Re: Notice of Intent Response Letter #1
0 Annette Lane (Map 38, Lot 139)
Reading, MA 01867
MassDEP File #270-0780

PROPOSED SITE PLAN

TITLE:	SHEET:
SITE IMPROVEMENT PLAN	C-102

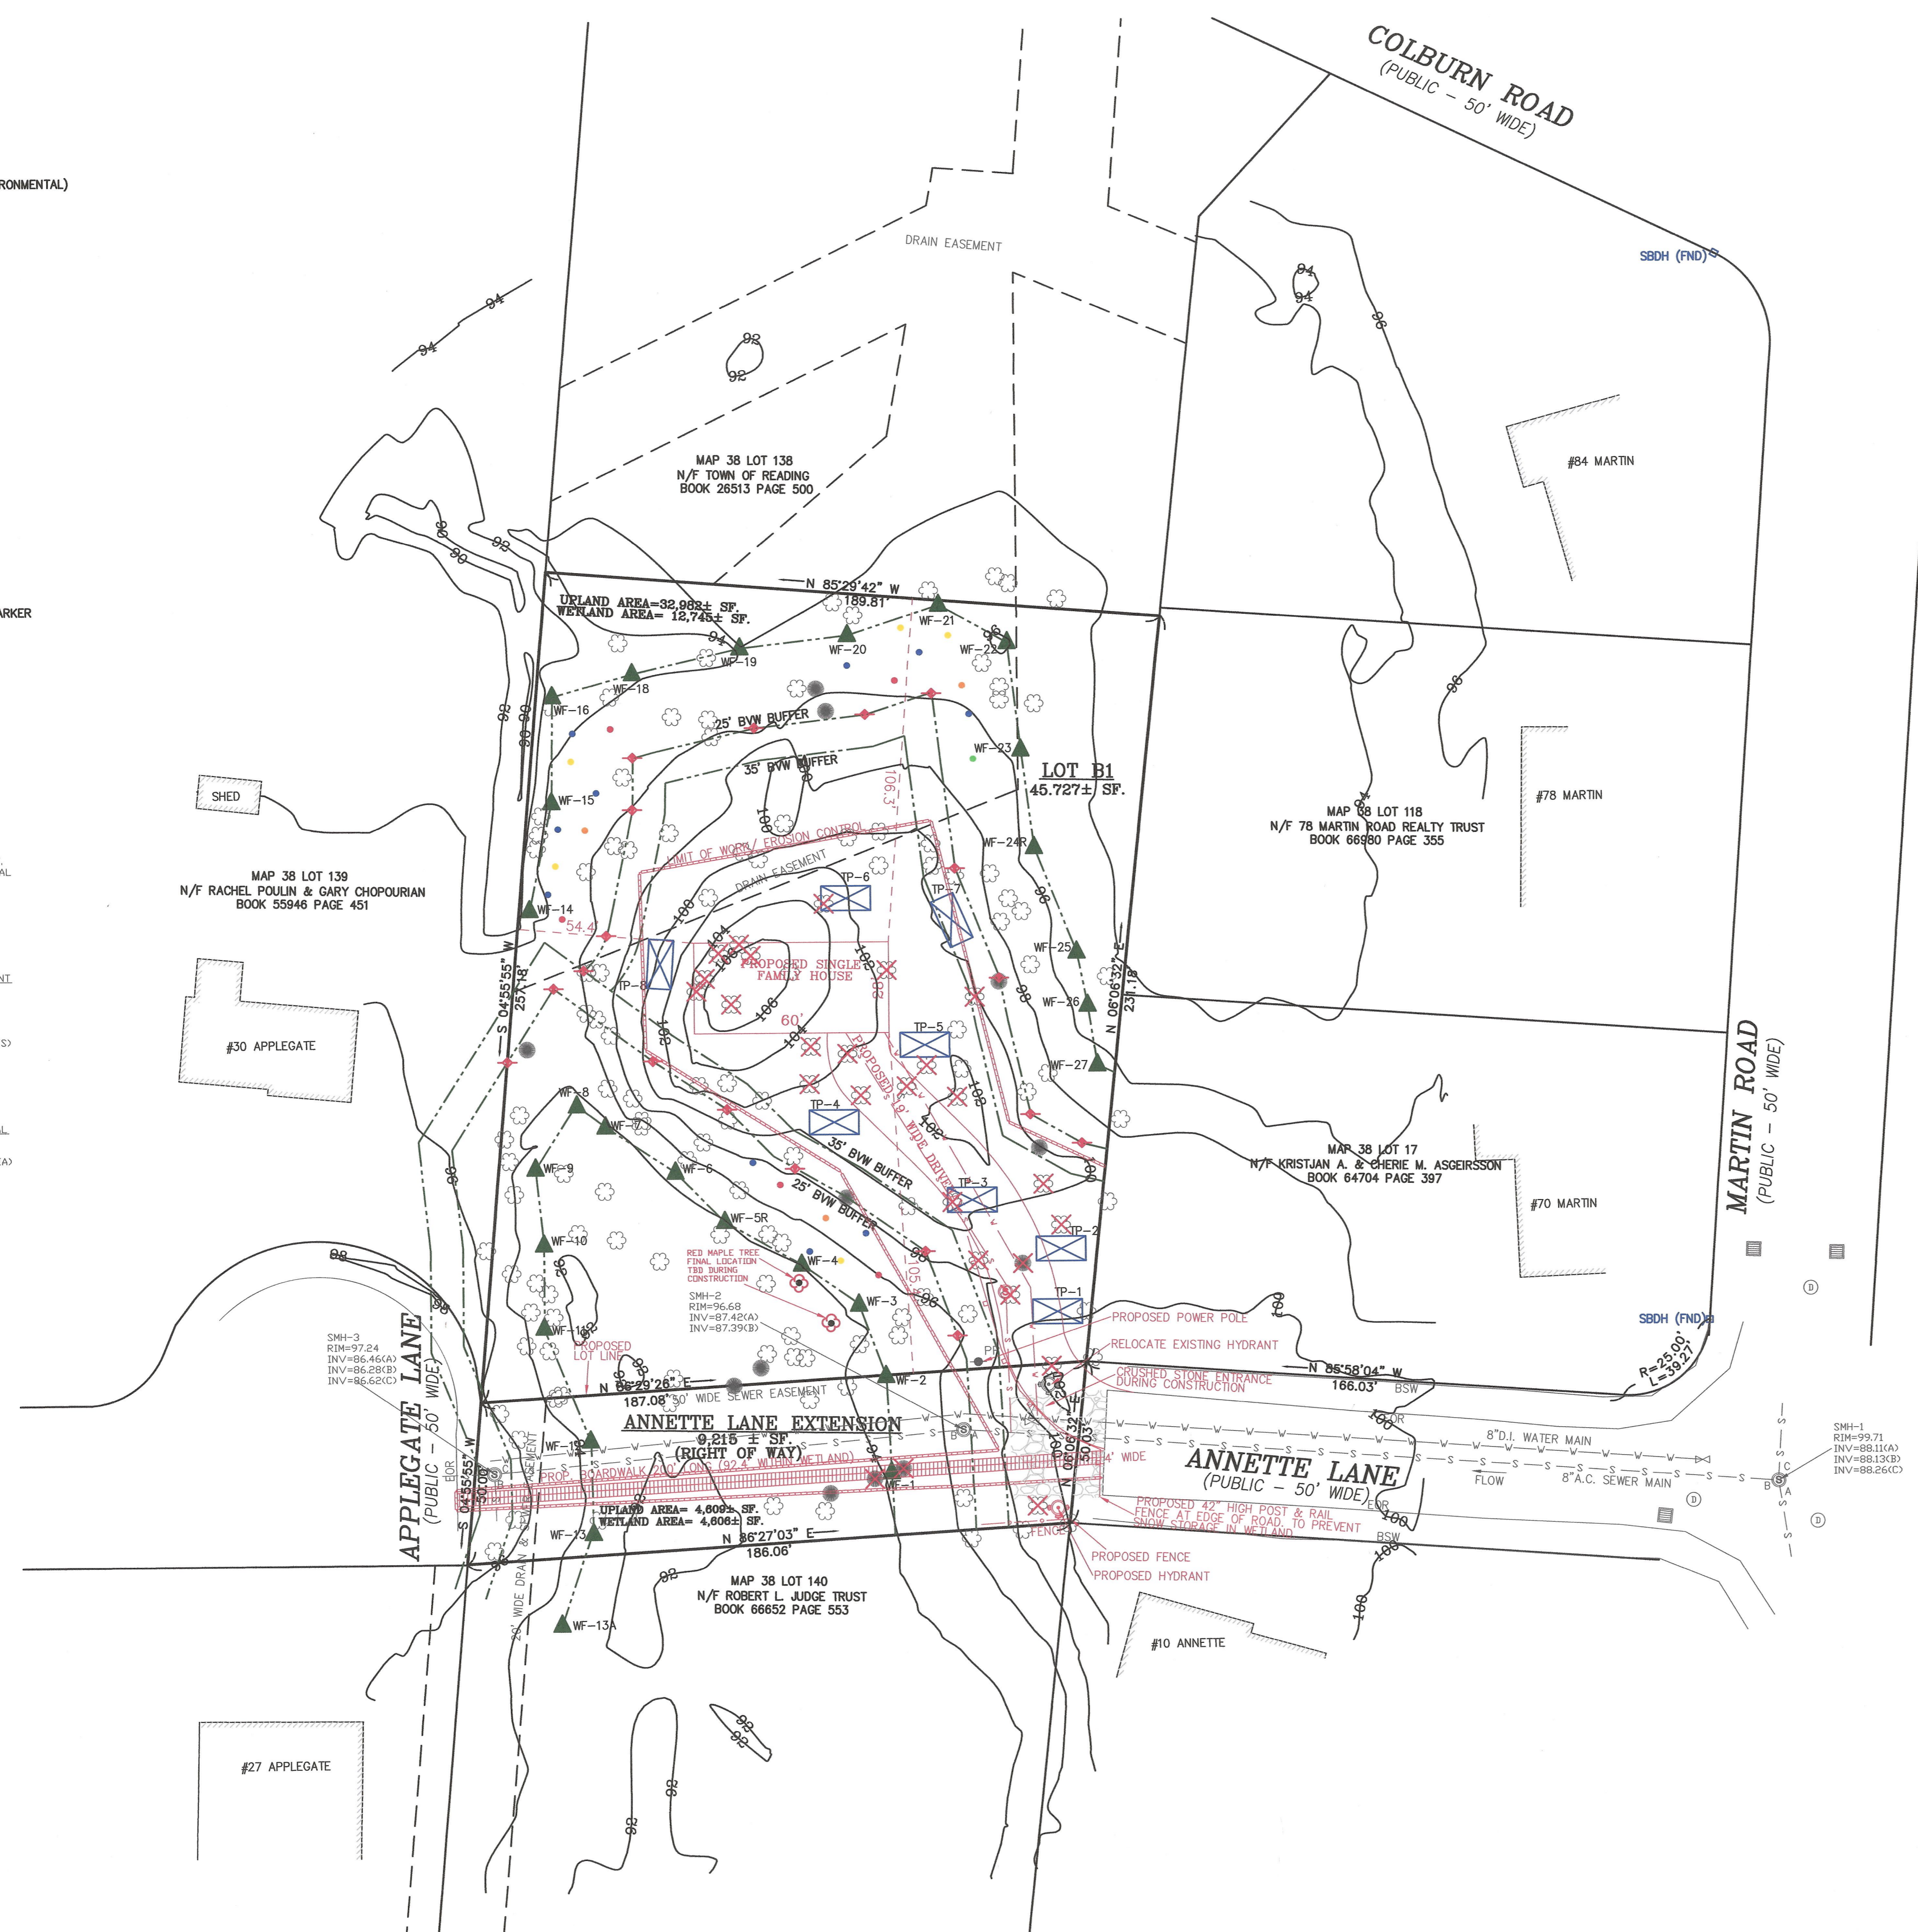
Due to site constraints, it is not possible to locate the proposed snow storage pretreatment area outside of the ZNV. After construction, this area will be seeded to reestablish native vegetative cover. At the request of the Conservation Commission, the Applicant is proposing a guard rail at the end of Annette Lane to prevent snow from the road being plowed into the snow storage pretreatment area.

Marker locations have been identified on the plans for the ZNV.

NO.	DATE	REVISION	BY
1	01.17.24	ADJUST LOT B-1 SIZE, WETLAND AND UPLAND AREAS. ADD RED X OVER TREES TO BE REMOVED.	AJF
2	02.05.24	SHORTENED ROADWAY EXTENSION. REMOVE SNOW STORAGE & PRE-TREATMENT AREAS. ADD POST & RAIL TO PREVENT STOCKPILING OF SNOW IN WETLAND. UPDATED TREE REMOVAL COUNT. ADD BOARDWALK BTD EXISTING EDGE OF PAVED RDWS.	AJF
